DATE: March 22, 2021

City Planning Commission 1300 Perdido St #7, New Orleans, LA 70112 FROM:John DauerPROJECT:Permit 21-03793-NEWC4535 S Claiborne Ave
New Orleans, LA 70125

In response to the comments made at the 3-17 DAC meeting we have made the following revisions to the design of 4535 S Claiborne Ave.

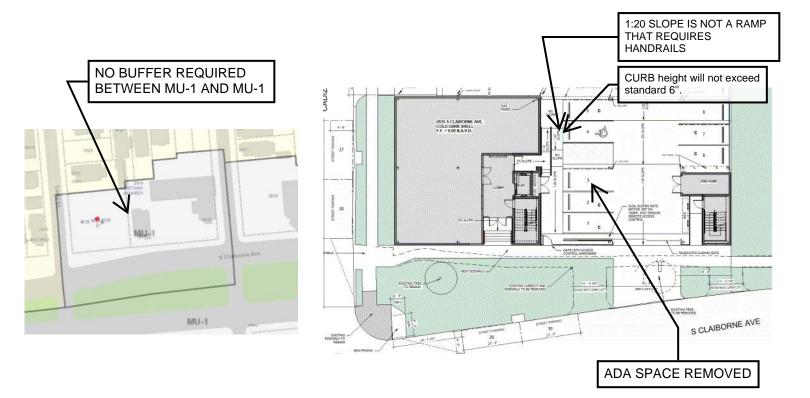
2. We have added an additional 5'x8' paving area near the bus stop and have aligned the side walks at the south east corner of the site. Revised site plan is attached.

4535 S CLAIBORNE DESIGN OPTIONS

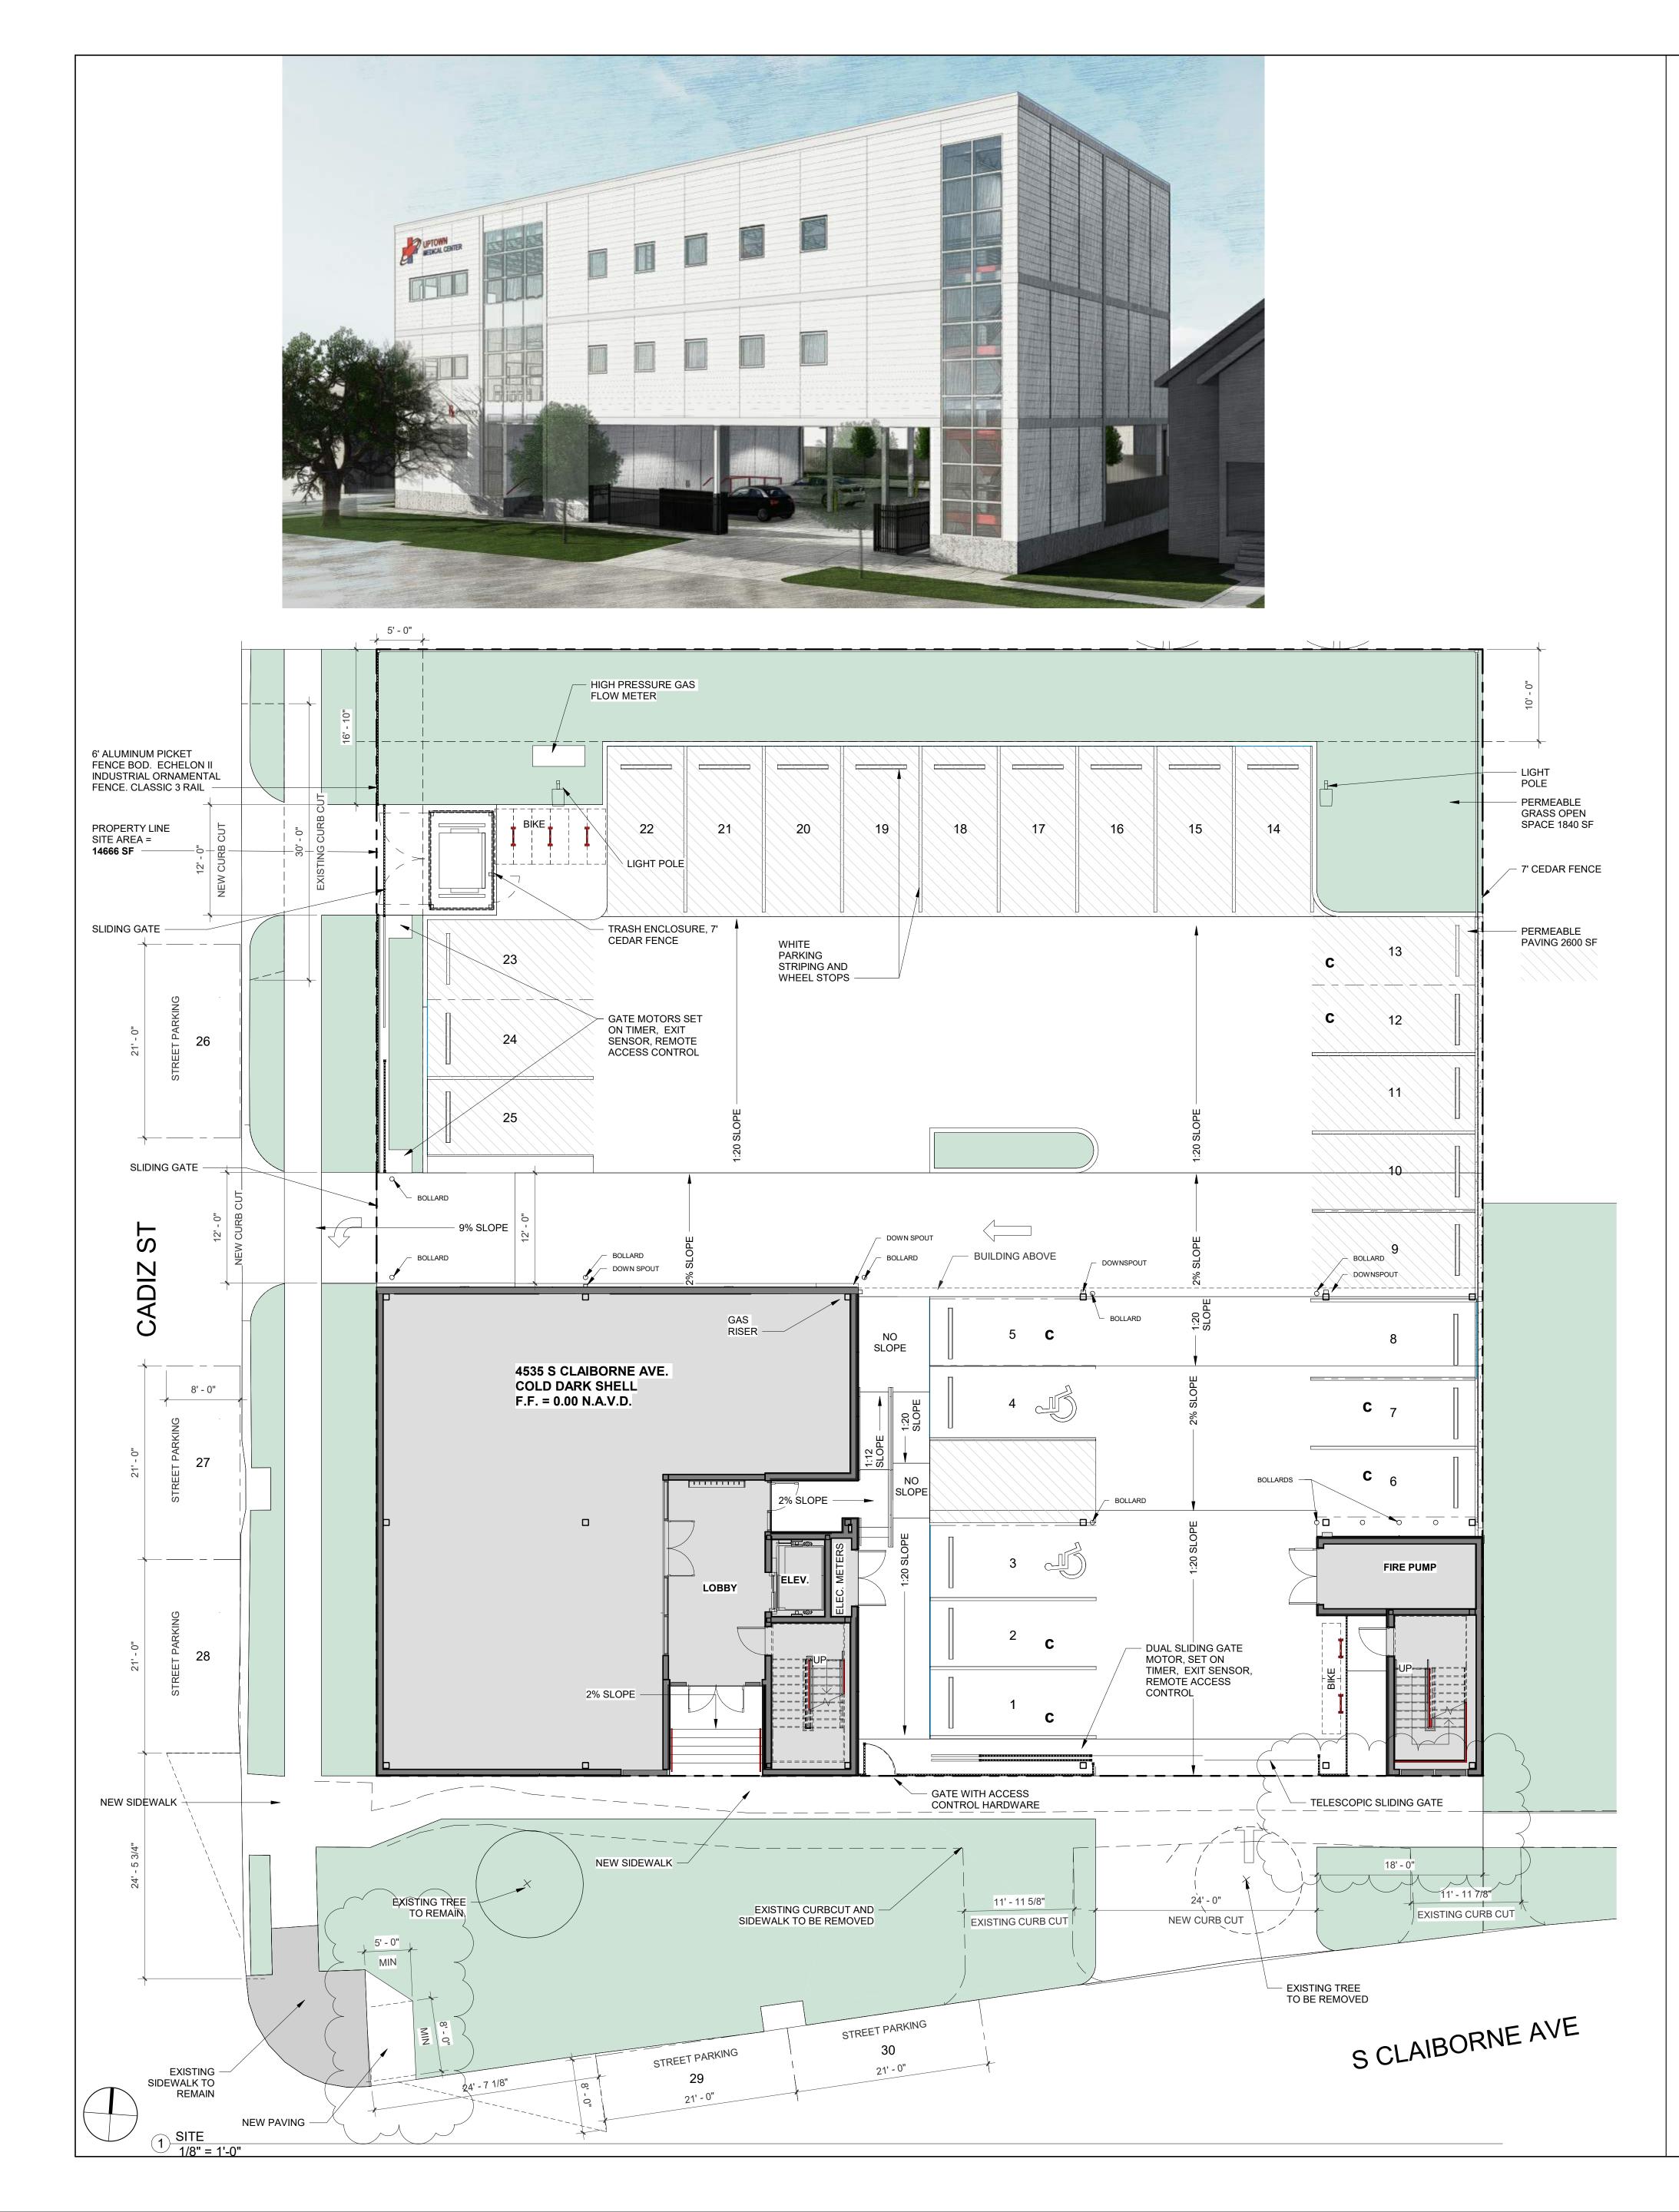
3. We have explored multiple options for expressing the exterior of the building and relating it to the surrounding residential and institutional structures. Attached are 4 options that incorporate variation in the facade and larger windows on the South Claiborne side. We have also attached a precedent image and images of commercial buildings surrounding the site. The precedent image is the owner's existing medical clinic. It is our intent to maintain brand unity with the existing clinic and 4535 S Claiborne in conjunction with incorporating the DAC's design suggestions.

OPTION 1 - CEMENT BOARD PANELS WITH ALUMINUM REVEAL TRIM. THIS IS THE OPTION PRESENTED AT THE 3-17 DAC MEETING EXCEPT WINDOWS HAVE BEEN ENLARGED.

OPTION 3 - CEMENT LAP SIDING 10" AND 5" EXPOSURE WITH ALUMINUM TRIM.

OPTION 2 - CEMENT LAP SIDING 10" EXPOSURE WITH ALUMINUM TRIM.

OPTION 4 - CEMENT LAP SIDING 10" EX AND ALUMINUM TRIM

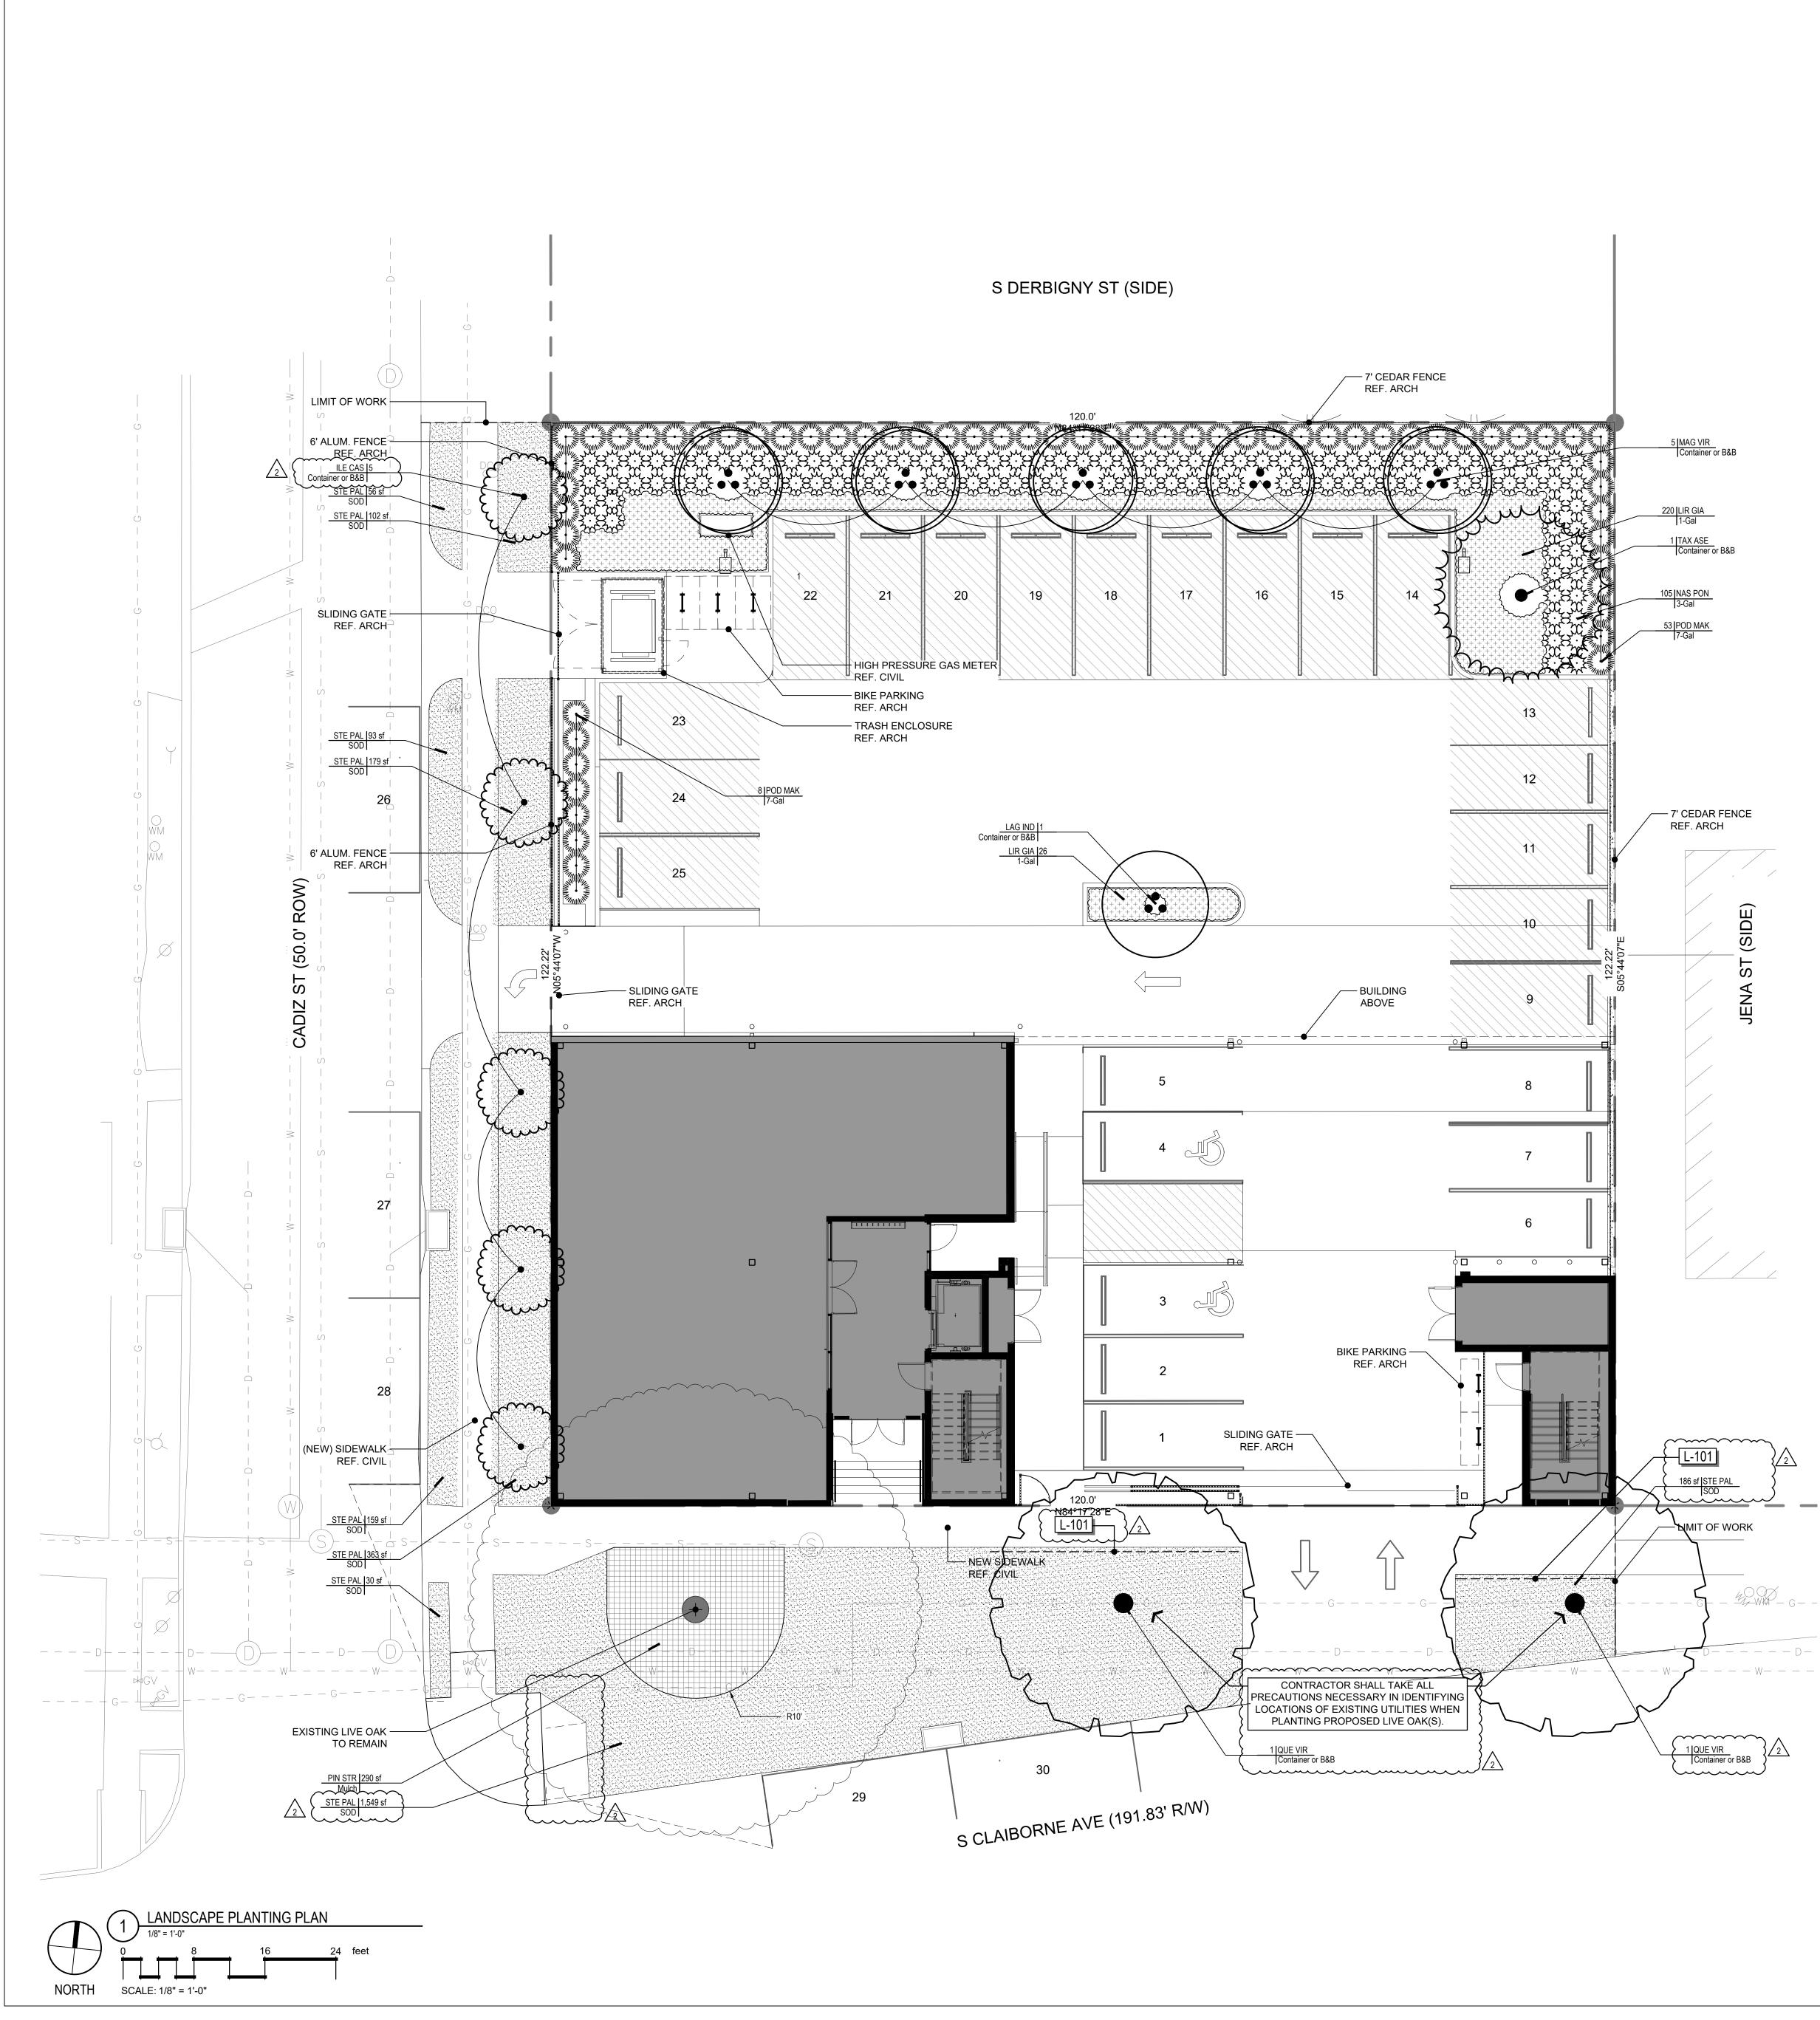
1. We have added two new Southern live Oak trees to S. Claiborne Ave to make up for removing one existing Live Oak. We have added an additional Dahoon Holly to Cadiz Street for a total of (5). Revised landscape plans are attached.
